Document Title		Removal of Wire from the Alternate Input Power Assembly				
Document #	Rev	Type	Reason	Recommendation	Original Release Date	
ZSB-014	A 2016/08/30	Service Bulletin	Error	Mandatory	2015/04/30

Removal of Wire from the Alternate Input Power Assembly (Hydraulic RHGSE Only)

Zephyr International LLC

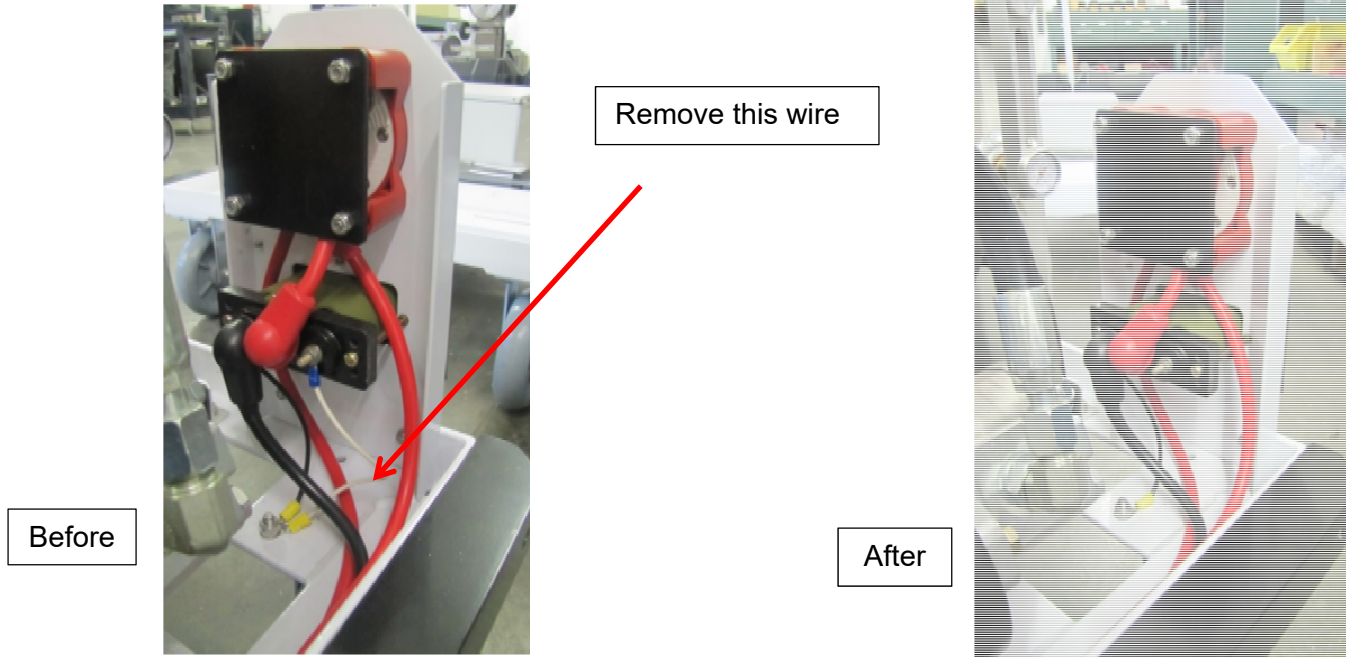
Reason: The third small terminal on the MS3506-1 receptacle was incorrectly wired to the frame, and needs to be removed. The third terminal is +28 volts. If the alternate input power plug is installed it will short out and burn up the small wire.

Procedure: Locate, remove, and discard the small wire jumper from the small terminal on the back of the 28 Volt receptacle and the frame.
